EASTRIDGE PLAZA
MINOR SITE PLAN
3095 SOUTH PEORIA STREET
AURORA, COLORADO

LANDSCAPE PLAN
5 of 6

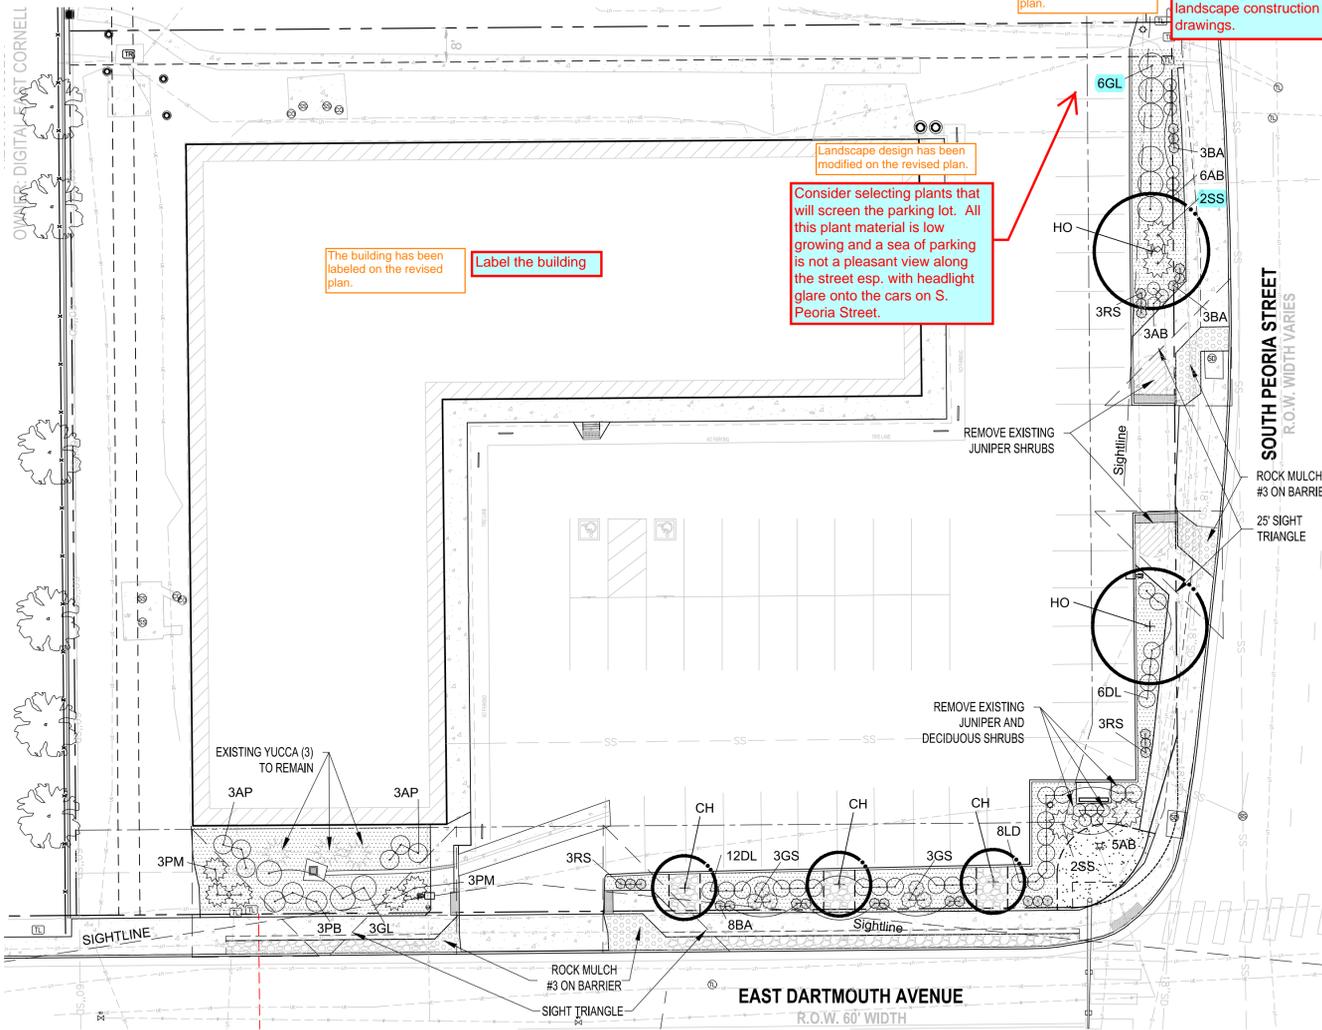
Despite the fire department's comment, please keep this note, but add their required notes as well.

Consider selecting plants that will screen the parking lot. All this plant material is low growing and a sea of parking is not a pleasant view along the street esp. with headlight glare onto the cars on S. Peoria Street.

Remove the stamp as the city does not review landscape construction drawings.

Is there a dumpster proposed? If so, include that on the landscape plan and provide a detail of the enclosure.

Remove all copyrights, typical all sheets.

The notes have been revised as directed with the new fire department note and keeping the previous note 10.

The stamp has been removed on the revised plan.

Landscape design has been modified on the revised plan.

The plan has been added to the revised plan, and a detail has been added to the architectural details.

The copyright statement has been removed on the revised plan.

1 SOUTH ELEVATION
 3/32" = 1'-0"

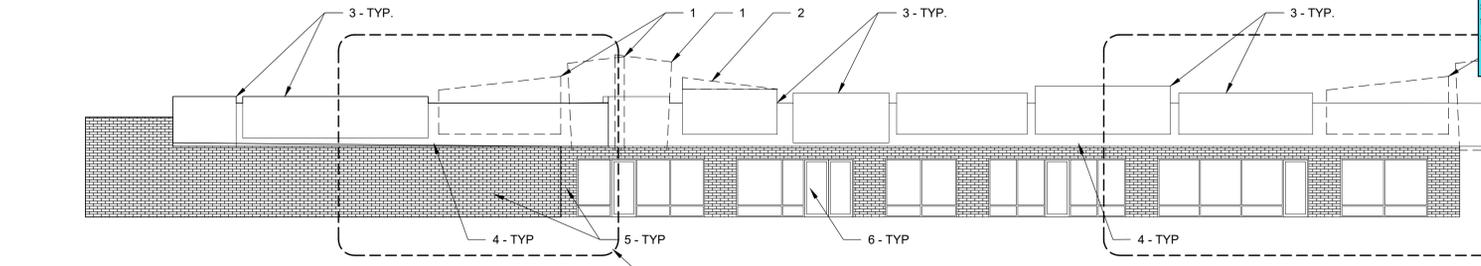
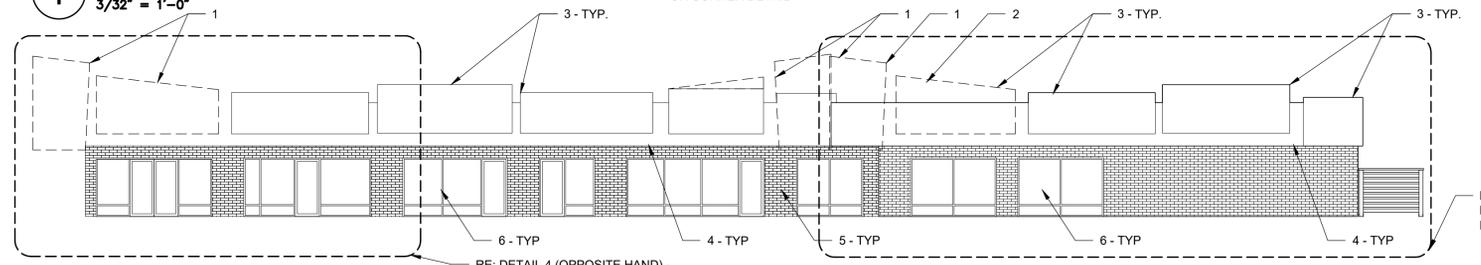
Please add the correct title block to each page. SP, LS Plan, Utility Plan, Grading Plan, Elevation and similar. Should match the Index on the cover sheet.

Title block from cover sheet has been slightly rearranged top text and applied to all other pages.
